CITY OF ALBUQUERQUE

**RE: Primrose School
Grading Plan
Engineer's Stamp Date: No Date
Hydrology File: C13D029**

Based upon the information provided in your submittal received 03/21/2018, the Grading Plan **is not** approved for Building Permit and Grading Permit. The following comments need to be addressed for approval of the above referenced project:

ENGINEER'S SEAL	PRIMROSE SCHOOL OF NW ALBUQUERQUE	DRAWN BY pm
		DATE 3-20-18
	GRADING PLAN	DRAWING
		 TIERRA WEST, LLC 5571 MIDWAY PARK PL NE ALBUQUERQUE, NEW MEXICO 87109 (505) 858-3100 www.tierrawestllc.com
RONALD R. BOHANIVAN P.E. #7868		SHEET # 4 JOB # 2017092

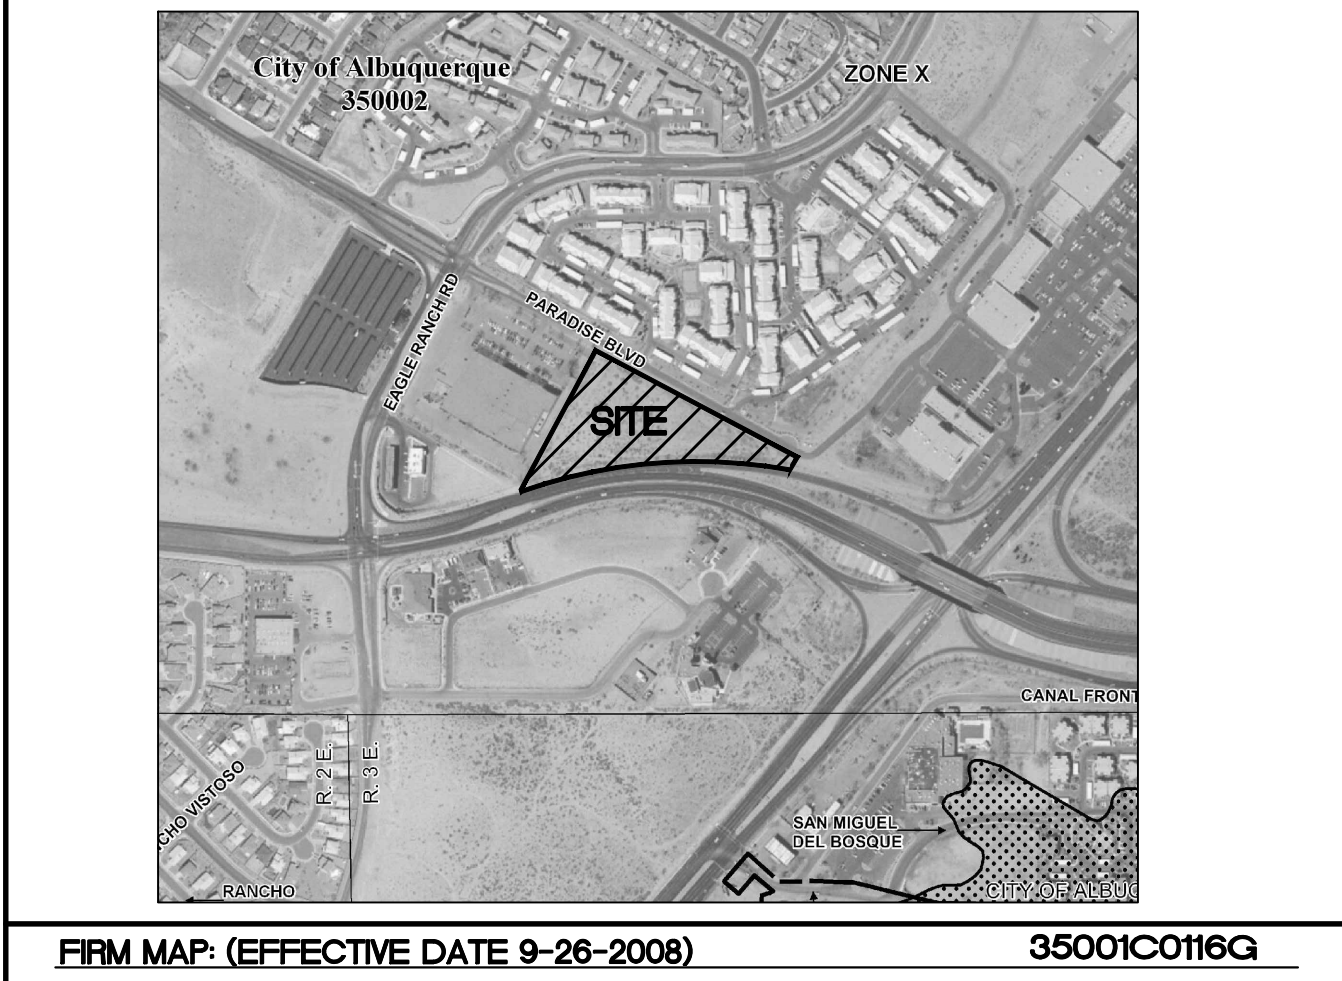
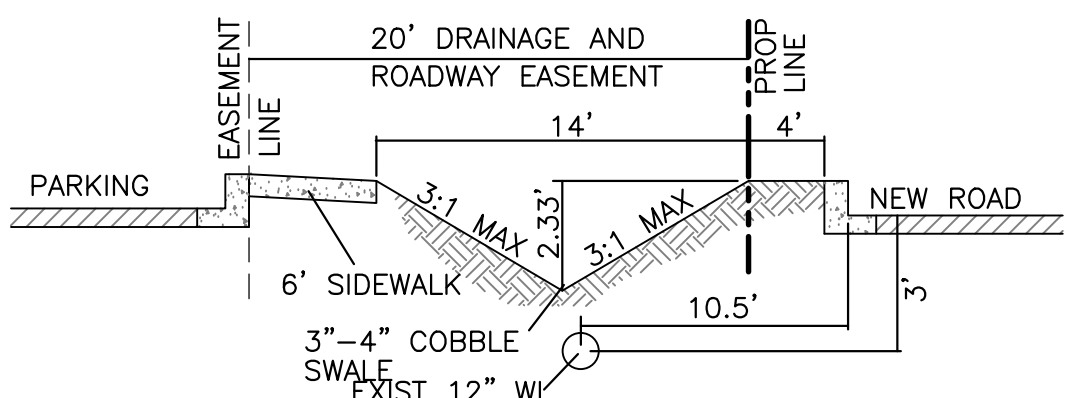
1. Please provide an engineer's stamp with a signature and date.
2. Please provide a drainage report that supports the proposed design with street capacity and all supporting drainage calculations. This report should reflect my comments instead of a regurgitated report from the previous design.

6. Please check the angle of repose for the proposed retaining wall with respect to the adjacent property. Per DPM Ch. 22.5.B, grading and construction of retaining walls at or near the property line must demonstrate that the adjacent property is not damaged or its use constrained. Any such encroachment by the wall or grading must be accompanied by written permission of both landowners.

7. Please show existing top of curb information along Paseo Del Norte at least at 50 feet apart.
8. Please show the existing drop inlet drainage information within Paseo Del Norte.

9. Please provide proposed elevations at both edges of the 10 ft asphalt trail, top of bank, flow line, and top of bank at 50 feet intervals along the southern property line.

10. There are missing grades within the proposed parking areas. Please provide them.
11. Please indicate if the proposed spot elevations within the proposed parking area are the top of curb or flow line information.

12. What is the purpose of the 20' Drivable grass? If it is for fire protection, then the firetrucks can only drive on a 2% max slope. Please fix.
13. Please correct the first flush calculation to 2,234 CF instead of 2.234 CF.

14. Please provide the weir calculation for the 3 ft curb cut.
15. Please provide a typical section of the 3 ft cobble swale.
16. Please provide proposed top of curb along Paradise Blvd.

17. When providing for the street capacity calculations, please emulation existing conditions just upstream of the site. The church gave 20 ft to the R.O.W. so at this location it is 106 ft then at the site becomes 86 ft. How is this transition of drainage being handled?

The church site has a point discharge into Paradise Blvd which I do not think that you have taken into account.

The proposed drainage swale and culverts within the 20 ft drainage easement collects public water, so therefore this needs to meet City Standards. Currently this does not meet them. The correct drainage solution for the street capacity overflow is to add public inlets and pipe that can handle the 54.11 cfs needed and have this pipe discharge into the existing detention pond. By having inlets and a storm pipe system will also alleviate the limited capacity of the existing concrete rundown.

Please provide a section from Paradise Blvd through the LID pond to Paseo Del Norte.

Please fix the outfall spillway for the LID pond. This should outfall into the street of Paradise at a proper angle so that the drainage is directed to the existing concrete rundown.
